4709 ROOSEVELT WAY NE

SDCI # 3038322-EG | MUP # 3036766-LU

EARLY DESIGN GUIDANCE MEETING #2

07.18.2022

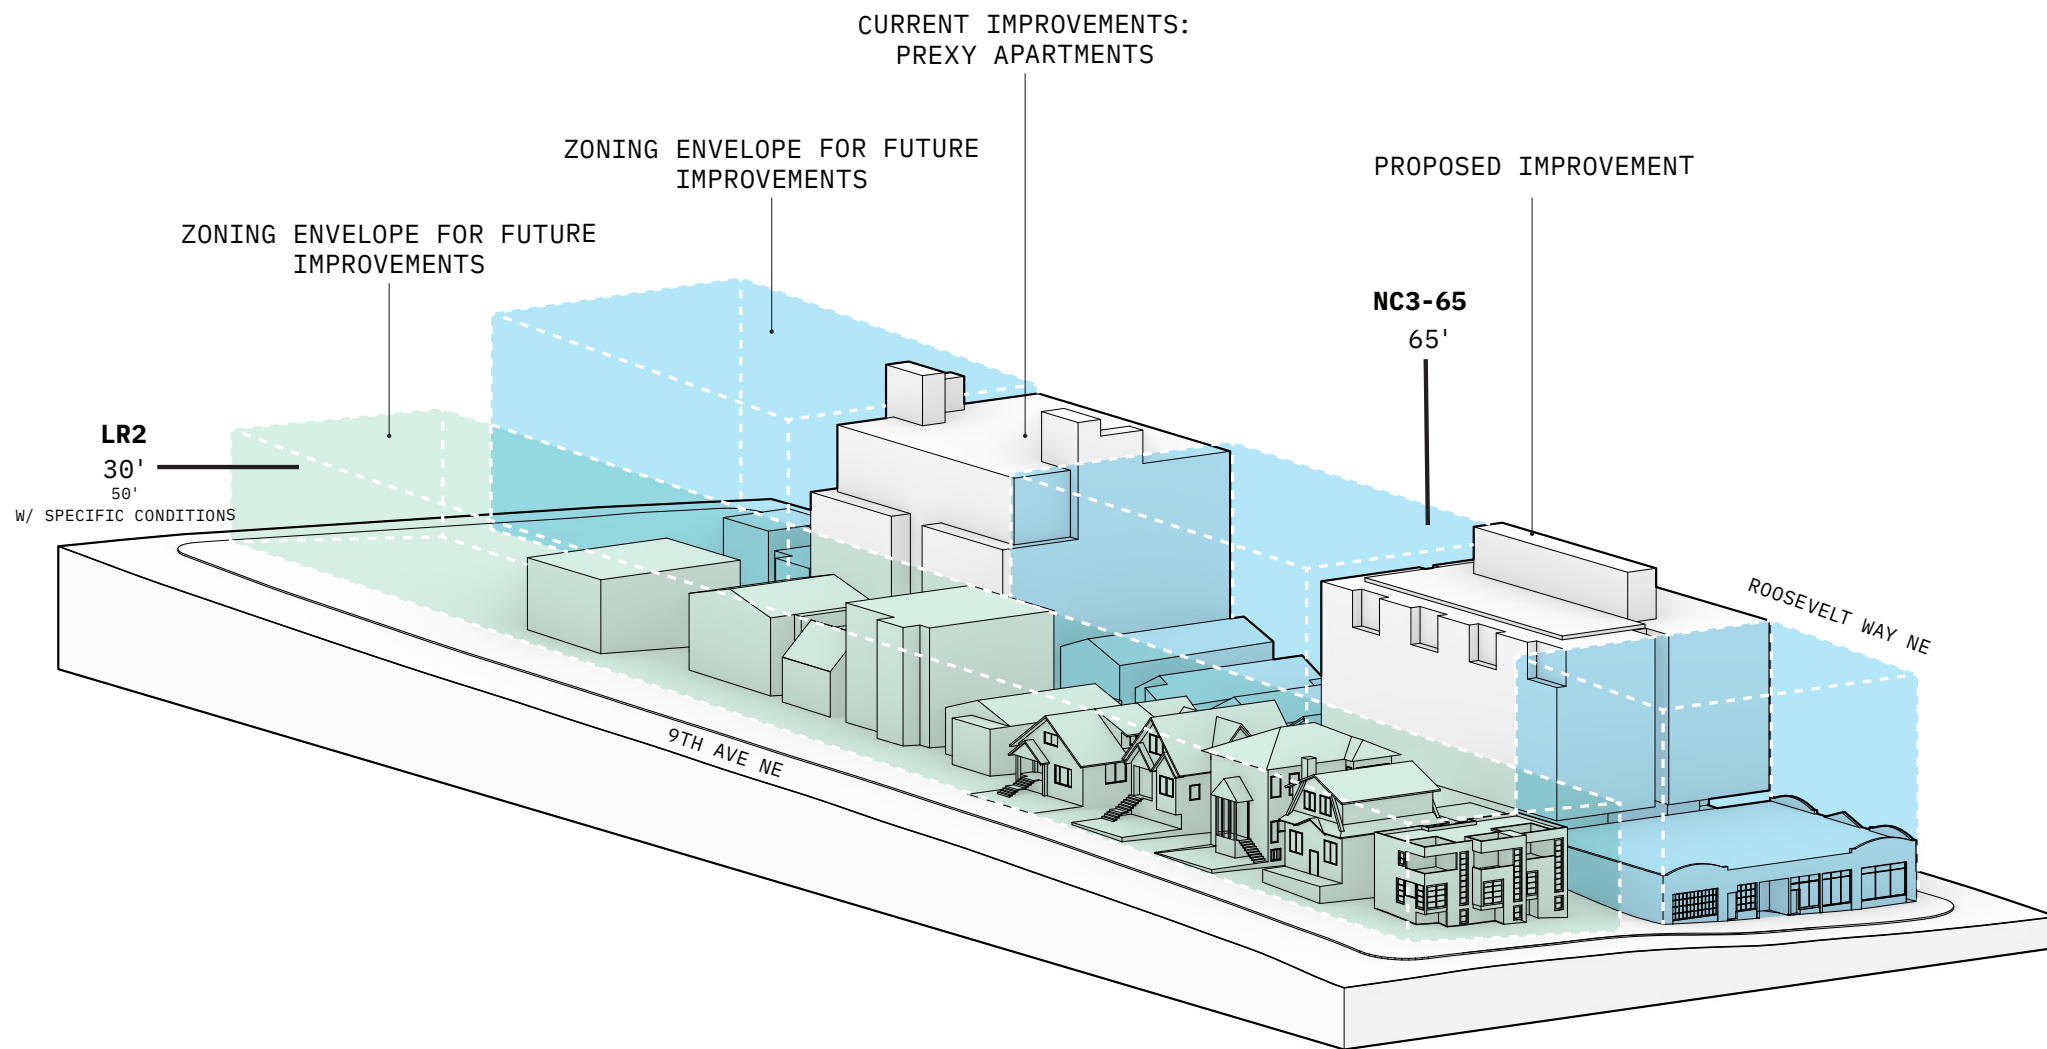
a. The Board discussed the lack of information contained in the packet regarding the building design's response to context. The Board noted that the packet did not go far enough with the context analysis, which made it difficult to understand the dimensional relationship between the proposed building and the existing building. . . (CS2.B.1, CS2.C.2, University Supplemental Guidance – CS2.1.e, CS1.1.c, DC2.2.a)

+ On the diagram to the left shows the original platting of the proposal's block and the adjacent block to the east. Additionally the different zones are indicated. There is a correlation between the original widths of the block and the intensity of zoning. The 30' wide blocks to the east are zoned for mixed-use structures to 240'. The block west was platted originally with 25' wide lot widths. The zoning further reduces in intensity from the neighborhood commercial zone (NC3-65) to the LR2 zone. This block framework and zoning establishes a grid and plan arrangement for the proposal. (Please see pp. 53-57,86)

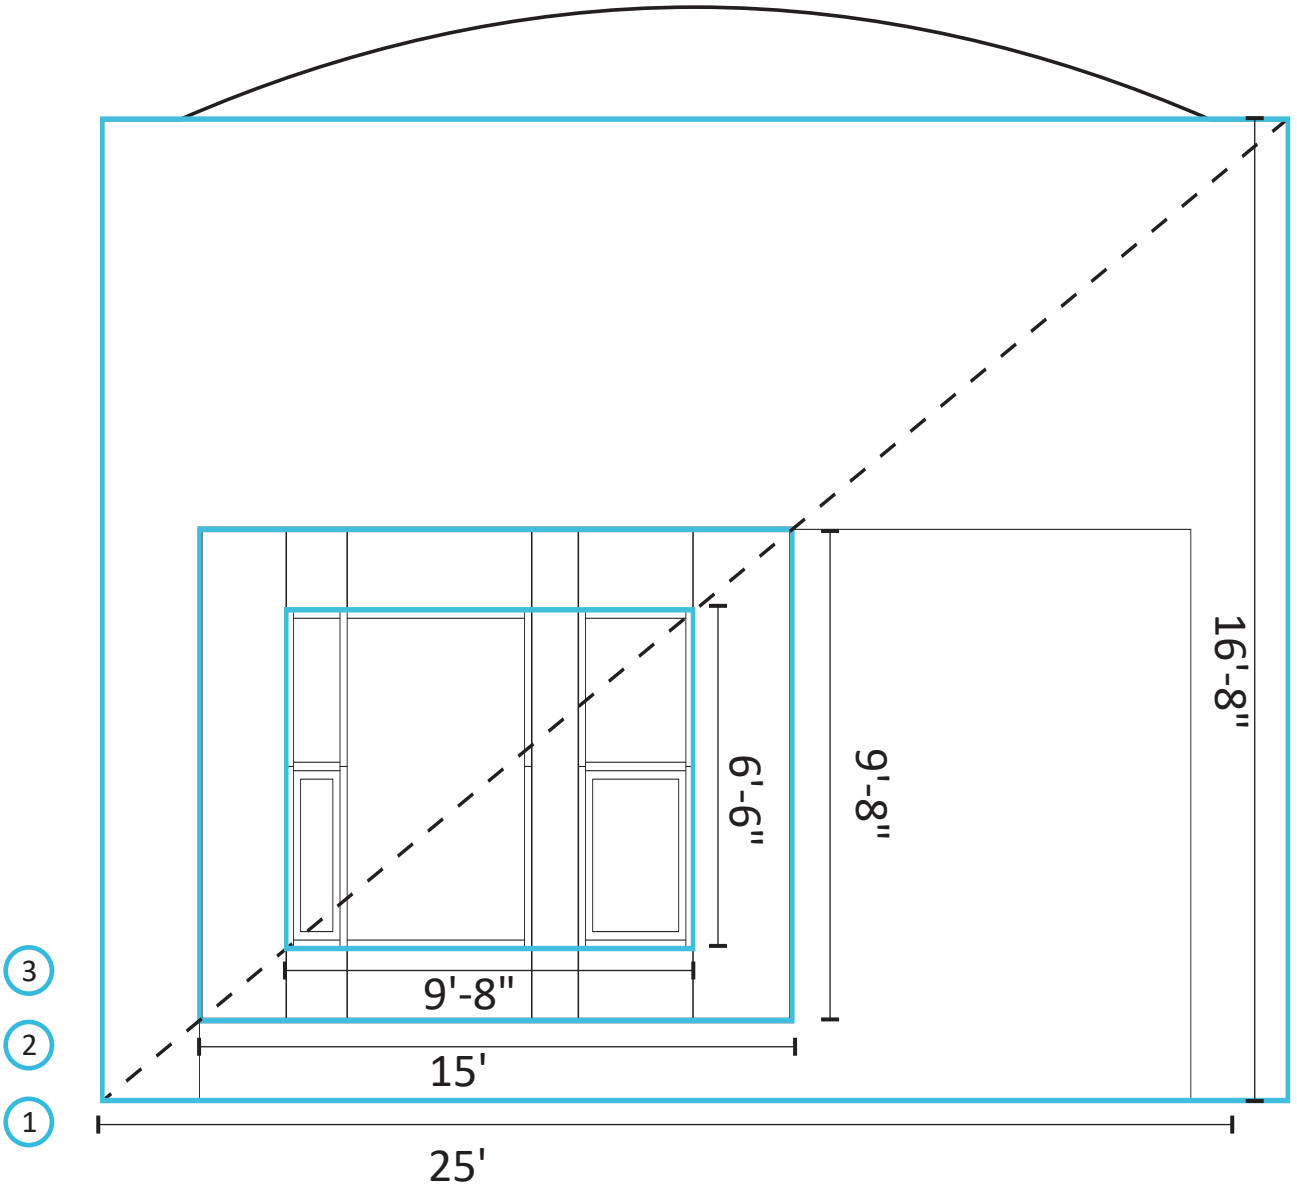
a. The Board discussed the lack of information contained in the packet regarding the building design's response to context. The Board noted that the packet did not go far enough with the context analysis, which made it difficult to understand the dimensional relationship between the proposed building and the existing building. The Board requested the applicant consider the existing building's relationship to the proposed building and how that could impact the north and south facades. The Board noted that the property immediately north of the project site is likely to be redeveloped due to the Existing underdeveloped nature of the site currently. However, the Board suggested the south facade of the building could be visibly prominent for years due to the existing building immediately south of the project site. The Board supported the use of balconies shown in Option 3 stating that this component was responsive to the existing context in the neighborhood. (CS2.B.1, CS2.C.2, University Supplemental Guidance – CS2.1.e,

Response: To the left is an overlay of the existing commercial structure's 25' wide module superimposed with the module of the proposed apartment building. Please see the following pages for additional information depicting how the context informed the proposal's massing and facade concept.

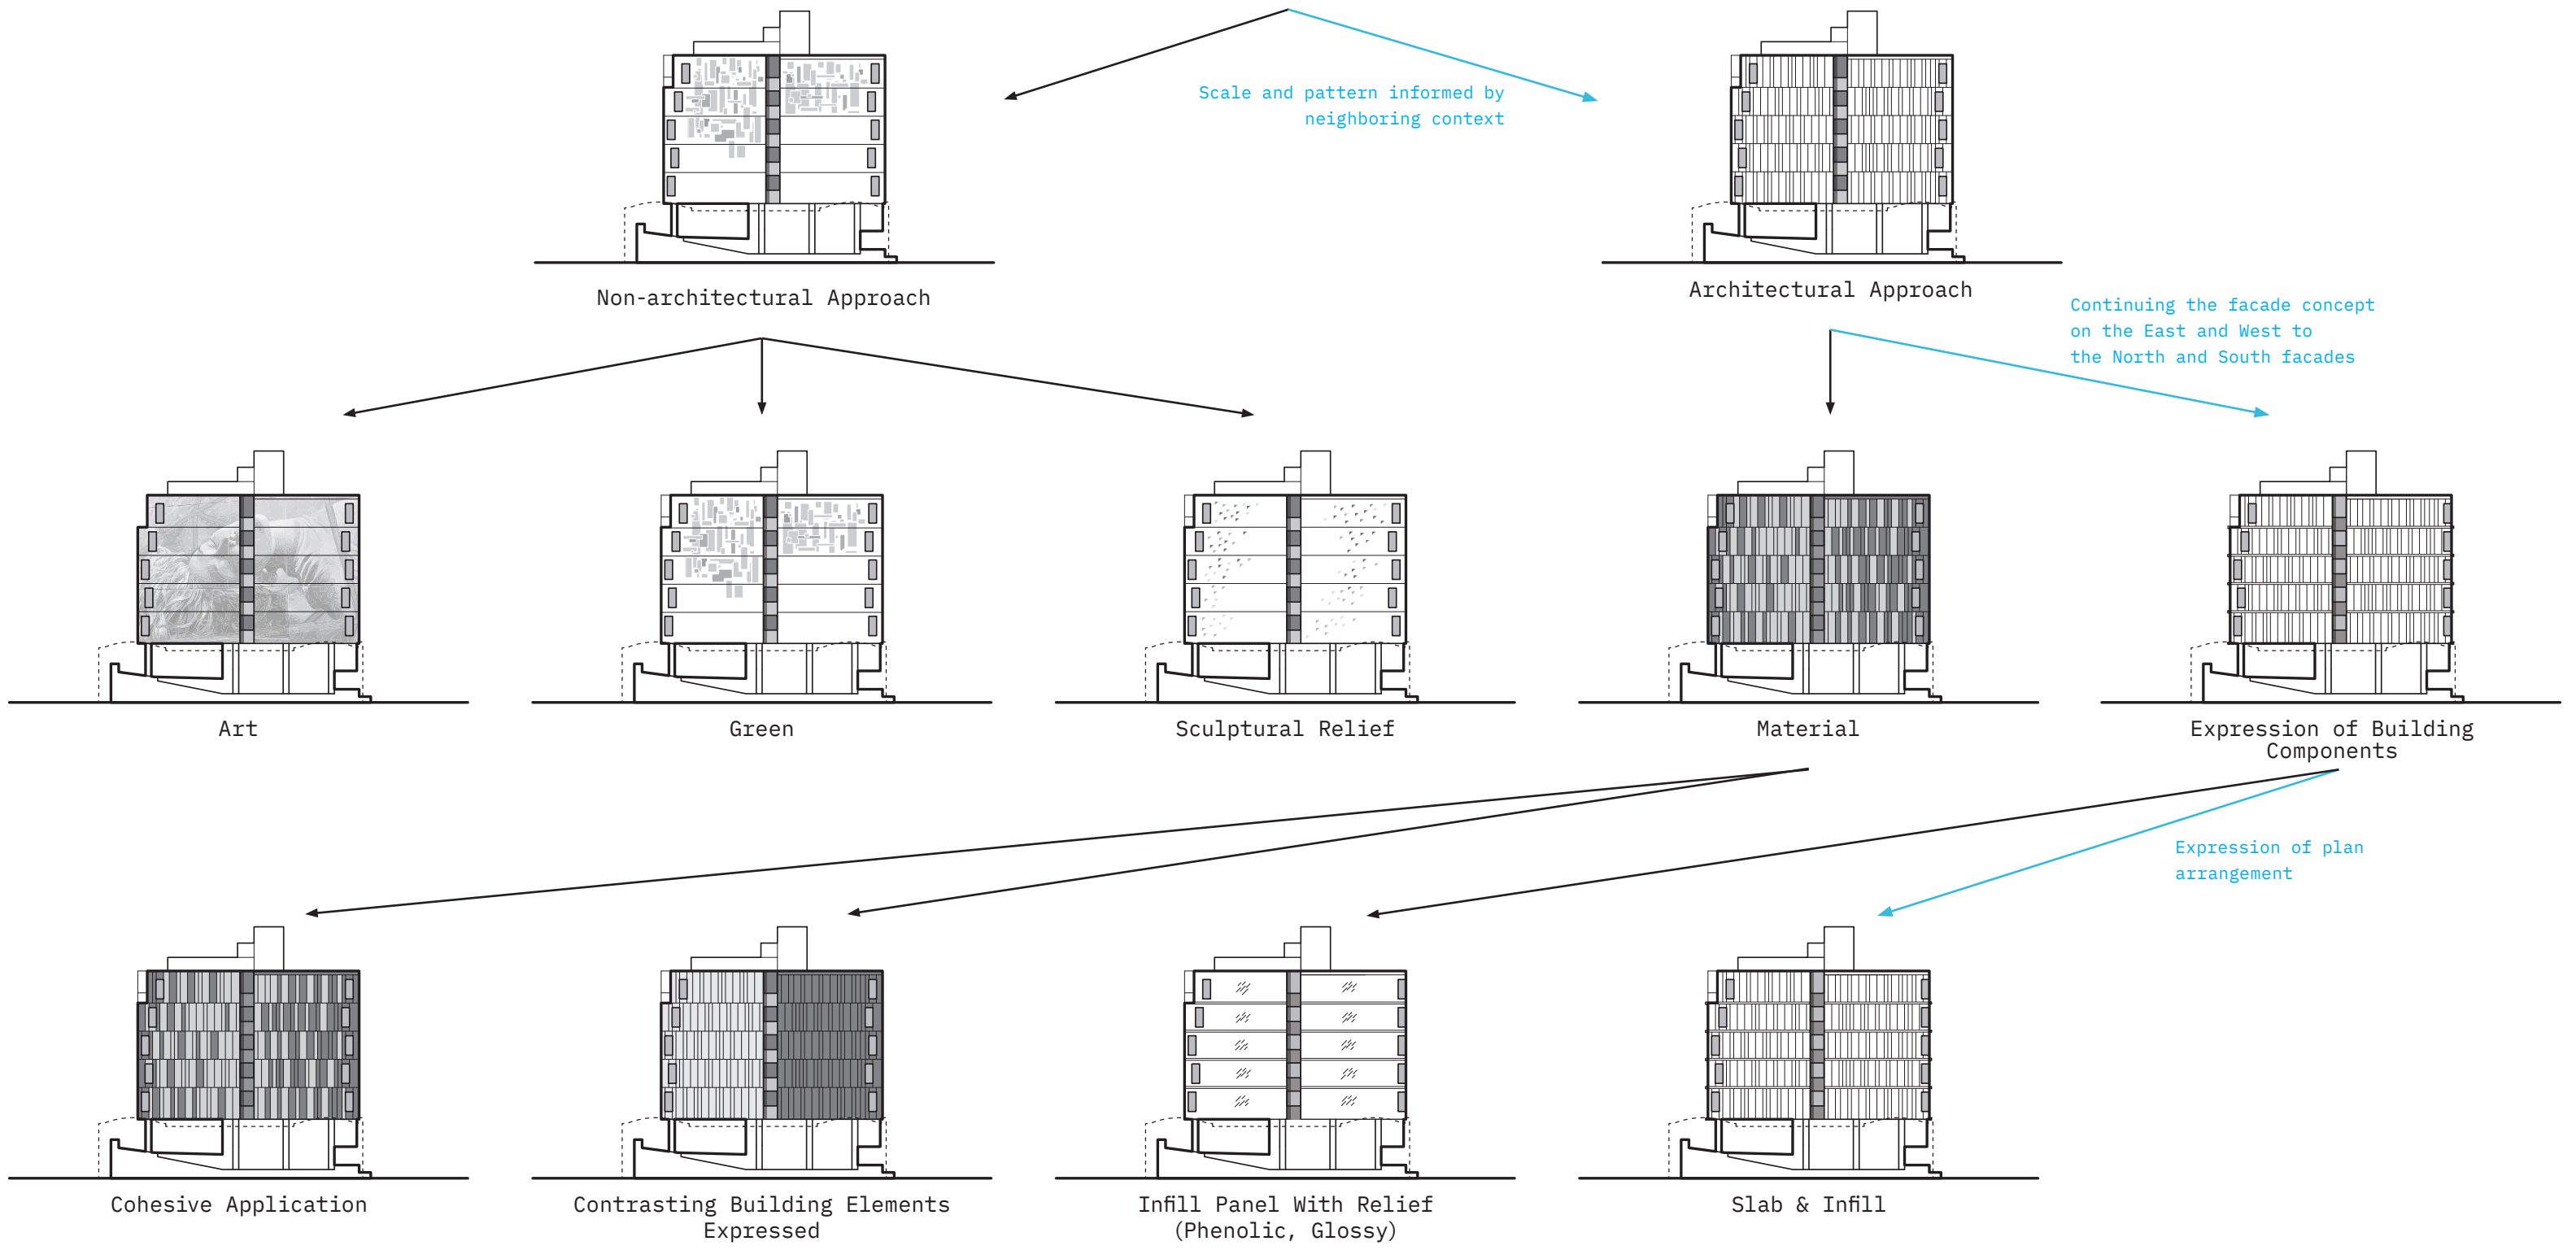
b. The Board was concerned with the lack of modulation on the building's south façade, noting their previous comment regarding the likelihood of this façade being visually prominent for years to come. The Board suggested more articulation along the south façade would be appropriate. (University Supplemental Guidance – CS2.1.e, DC2.B.2)

Response: The project's interior facade design considered several means to enhance facades that are temporarily visible due to the adjacent underdeveloped buildings. The goal for the interior facades is to add interest and variety while acknowledging the facades may not be visible once the adjacent properties are developed to the same intensity of the proposed. The highlighted options "Material" and "Architectural" are two strategies proposed. By selecting a consistent, material appropriate for all sides of the building and adding variation could promote a cohesive design. Breaking the interior facades into two sections and introducing limited amounts of glazing would reduce the scale and add interest.

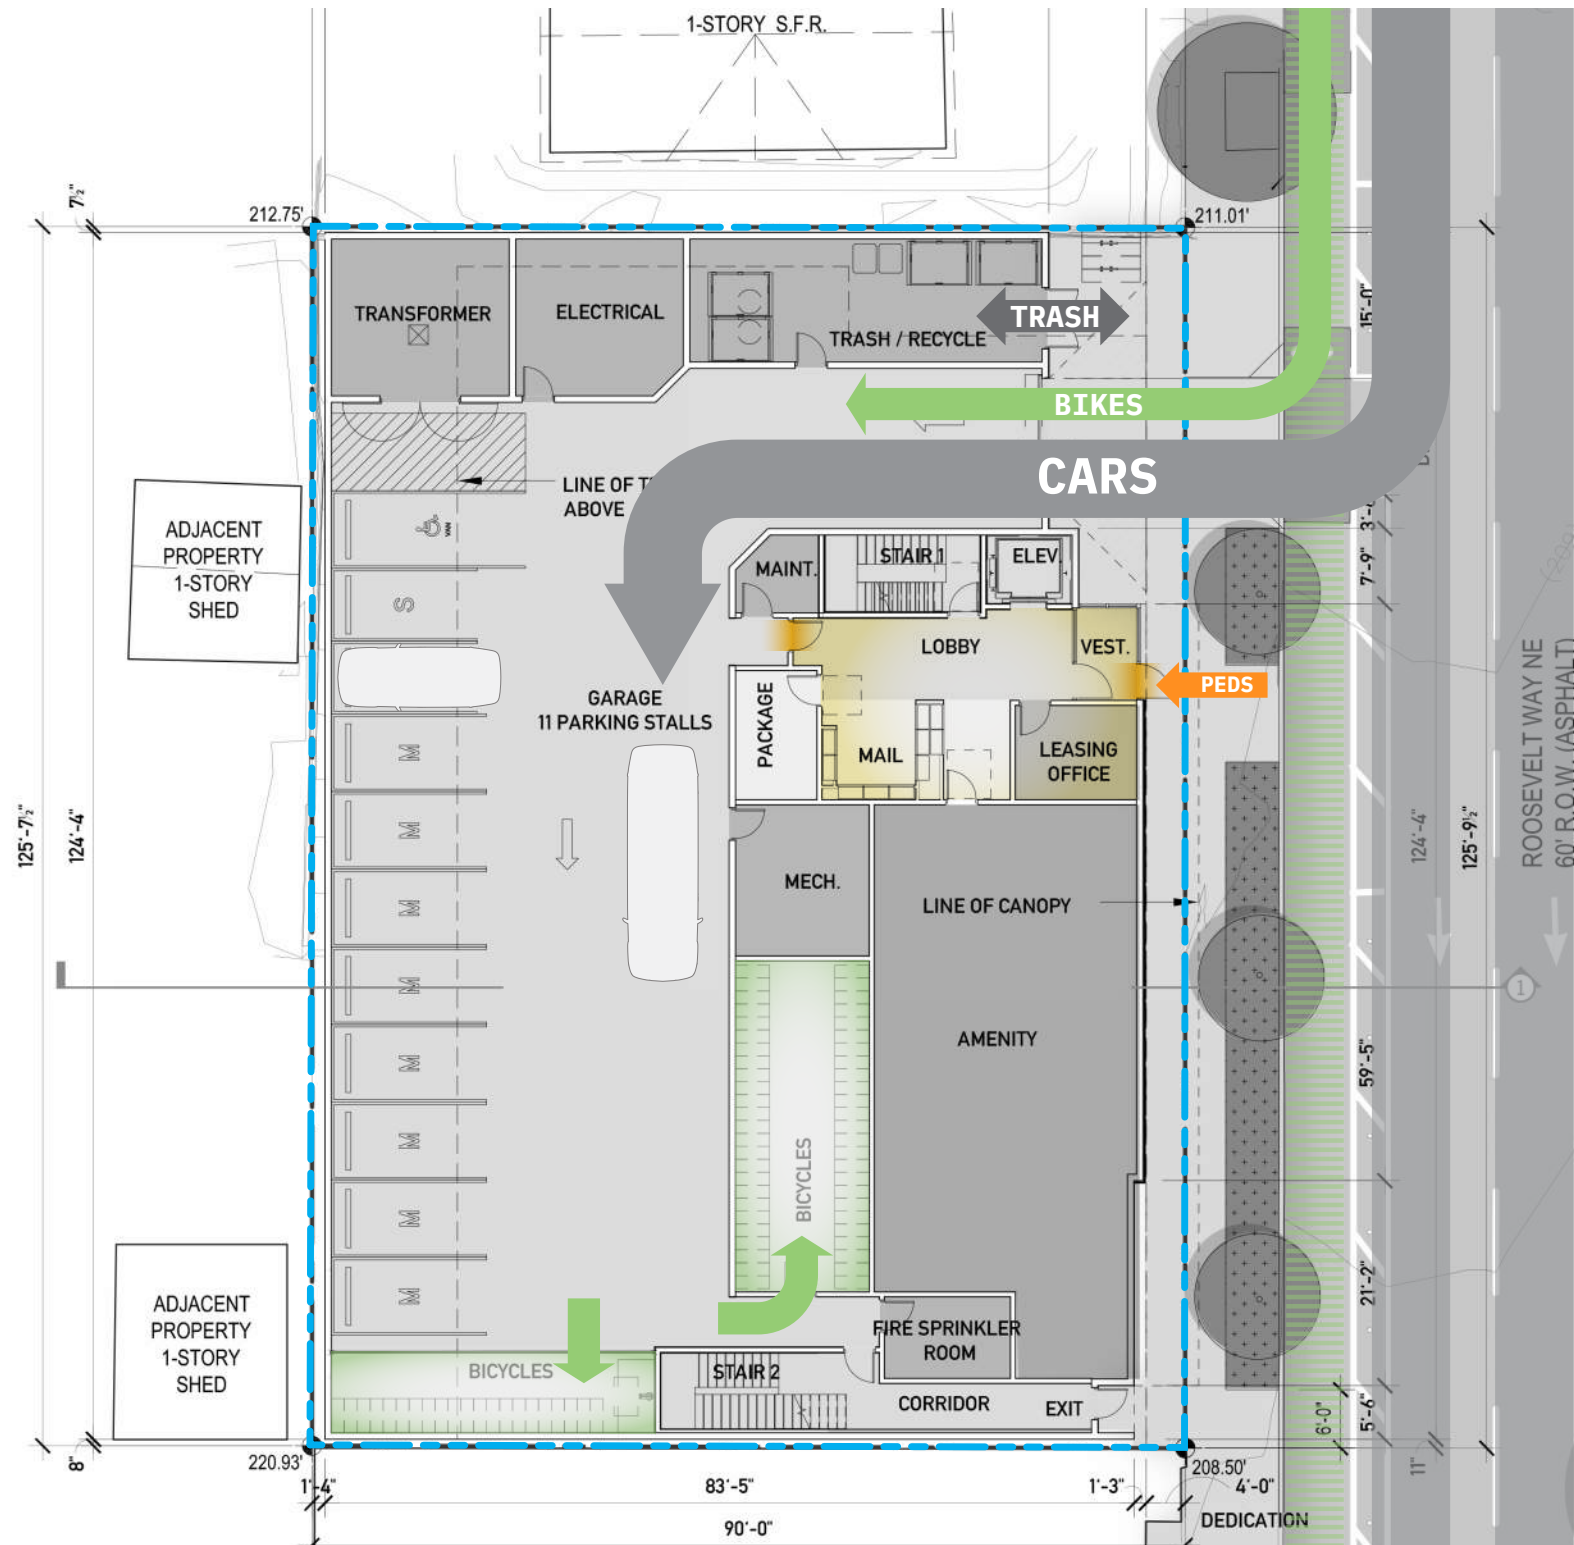
a. The Board requested the applicant provide a calculation of the required amenity area for the Board members to better understand what the required minimum amenity area for the project is. In addition to this information, the Board requested the applicant provide opportunities to introduce a commercial space at the street level.

The Board was concerned the large amenity space at the street level would not activate the street and instead create a dead zone along the building's street frontage.

The Board requested the amenity space provide the flexibility to permit a future commercial space(s) to provide for street activation. The Board requested the applicant study the adaptability of the amenity space to convert to commercial spaces in the future. **(DC1.A.3, University Supplemental Guidance PL3.3.f, PL3.3.d, PL3.3.e)**

b. The Board expressed concern that the largest massing move along the street level was associated with the garage entrance. In addition, Board members had concerns that the primary pedestrian entrance was too close in proximity to the garage entrance. The Board recommended the pedestrian access become more unified and requested studies for different entrance locations to better separate the pedestrian entrance from the garage access. This change in the lobby location would coincide with changes to the interaction with the lobby and amenity space. **(University Supplemental Guidance PL3.1.a)**

+ Response: Please see following page
